**Flight Operations Simulation  
and Analysis Branch, AFS-440  
Technical Report -  
# DOT-FAA-AFS-440-6**

***Proof-of-Concept  
Demonstrations for the  
Proposed Runway 17R  
End Around Taxiway (EAT)  
at Dallas/Fort Worth  
International Airport (DFW)***

**November 2004**

# Perimeter Taxiway System

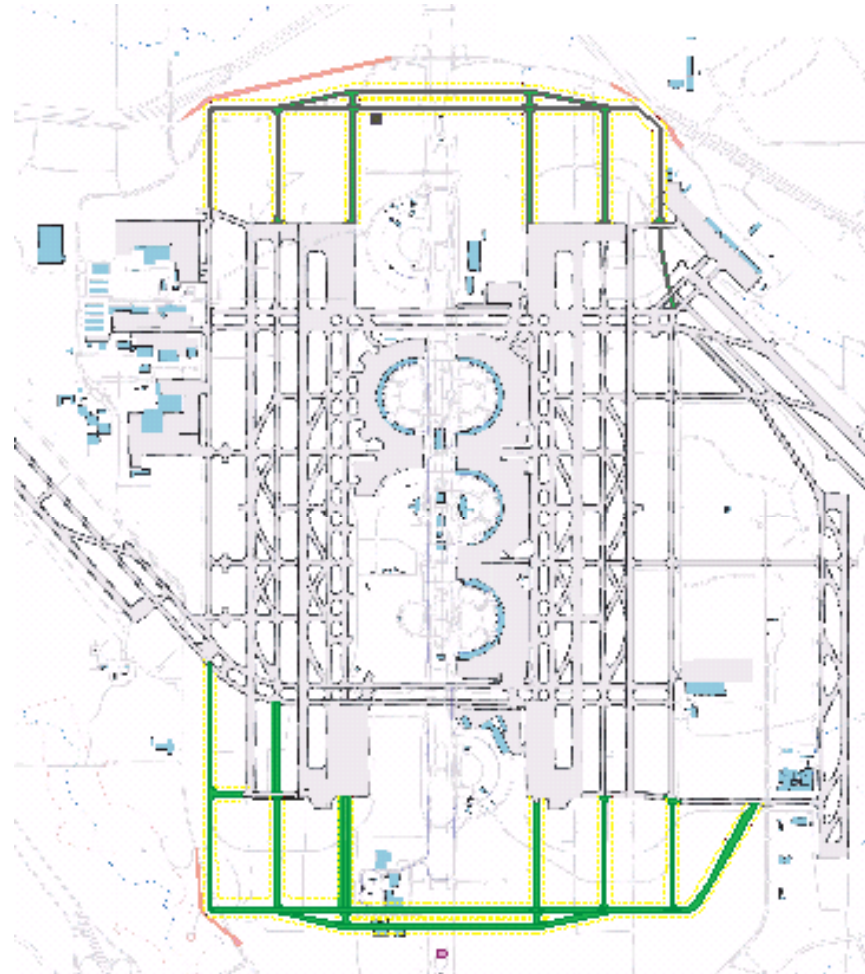
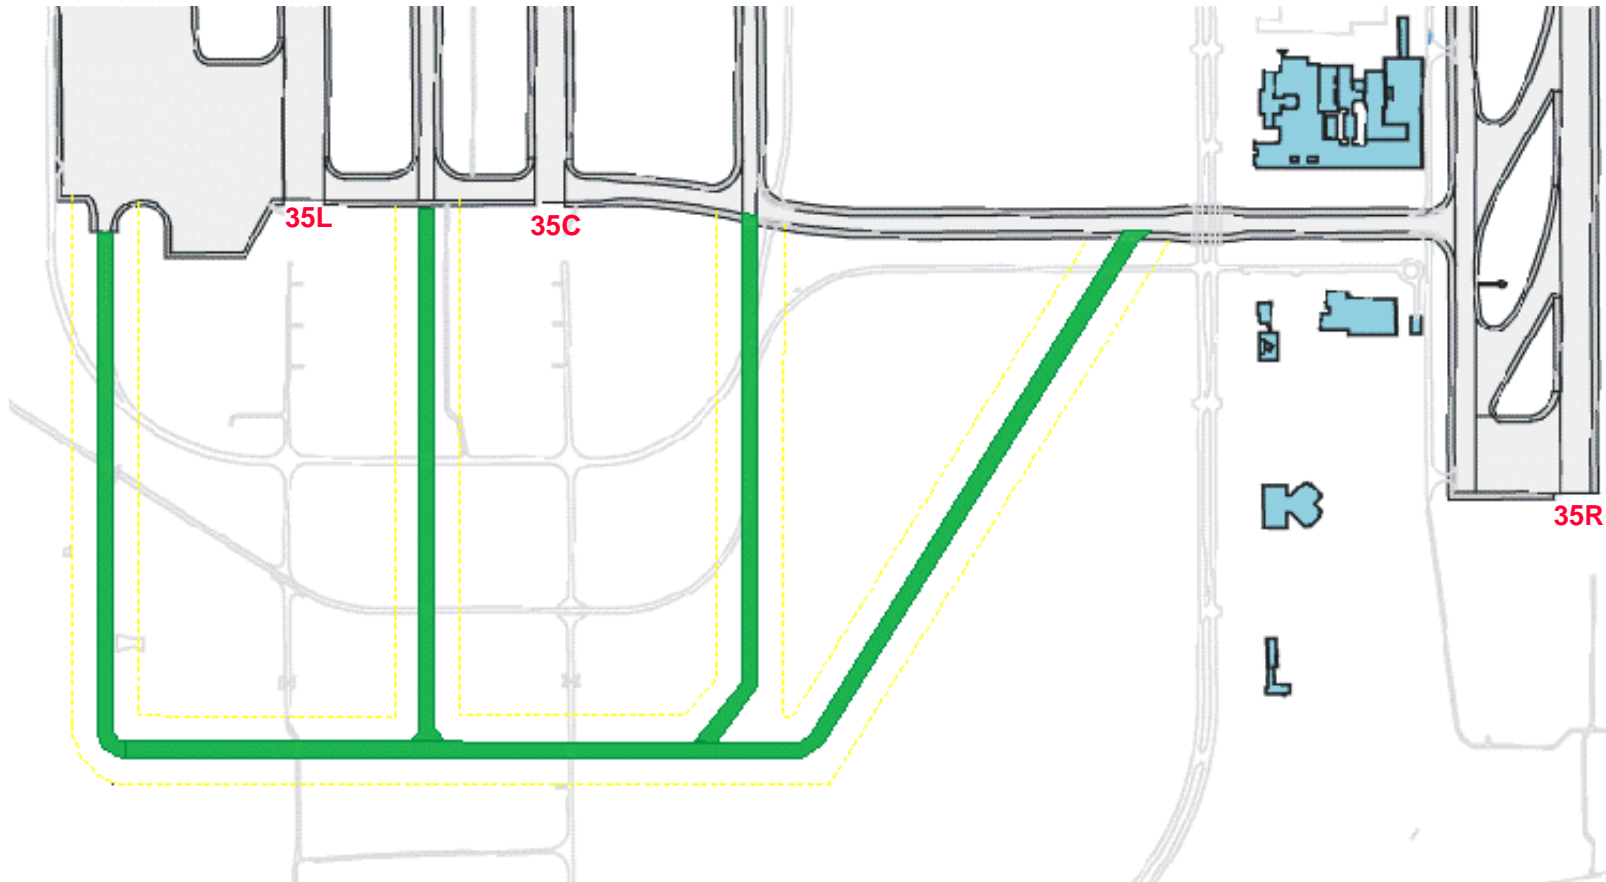
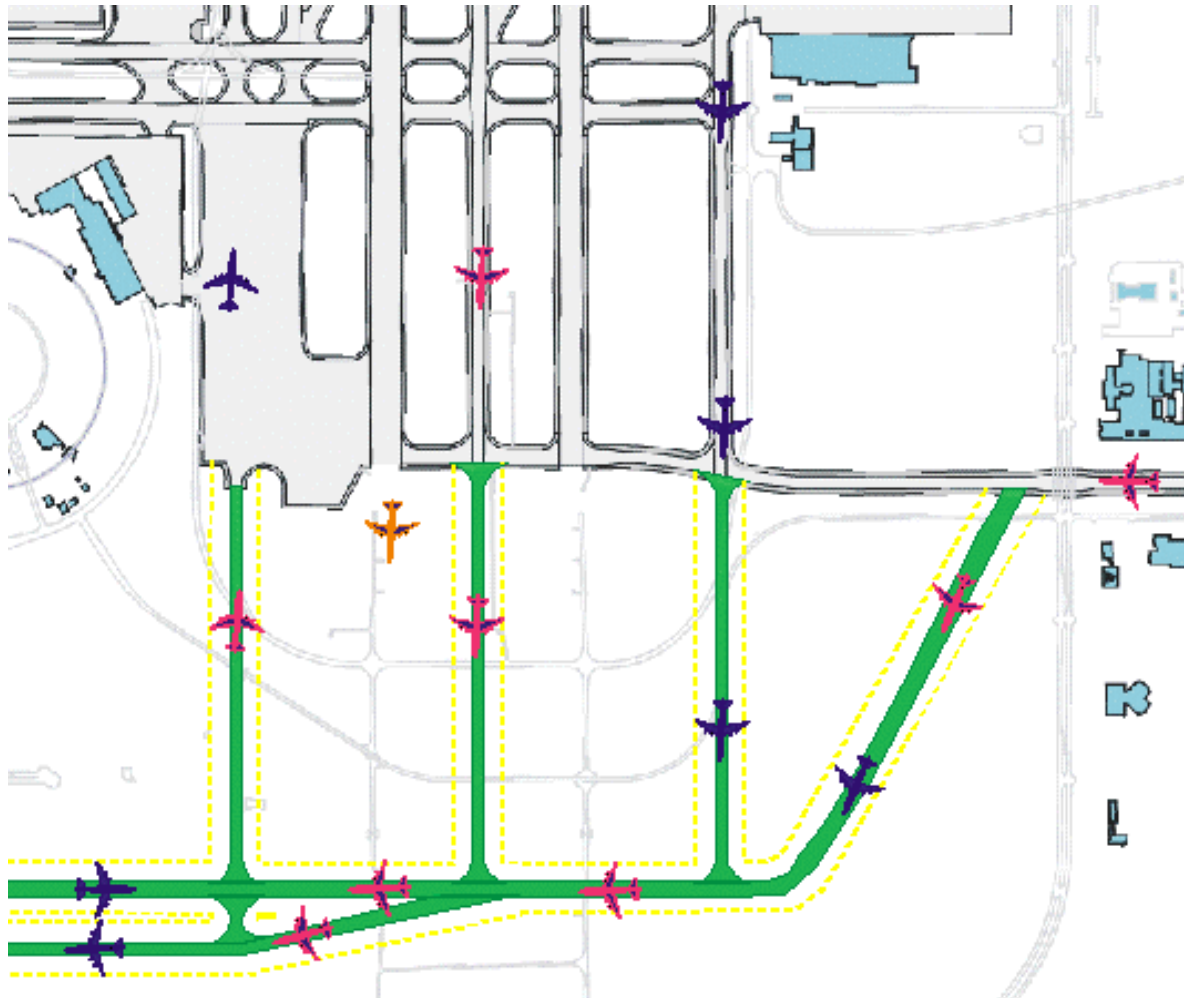
However, the proposal for an EAT system to be put in place at DFW should not be approved to move forward in its current form. The data from this demonstration confirms that, as suspected, there is an increased risk of an incident because of the potential lag in acquiring and confirming an incursion is present. Not only did several participating crews fail to identify an incursion, but more than half indicated that a potential problem existed with operations conducted in the current proposal.

Further investigation may be needed to: 1) identify crew training requirements; 2) develop mitigation strategies to increase the conspicuity of aircraft on the EAT or crossing the centerline, thereby preventing pilots from mistaking an incursion aircraft for an EAT aircraft; and 3) identify and establish EAT-specific operational procedures. Conclusions drawn from this data, analysis, and demonstration cannot be broadly generalized to other runways or other locations.
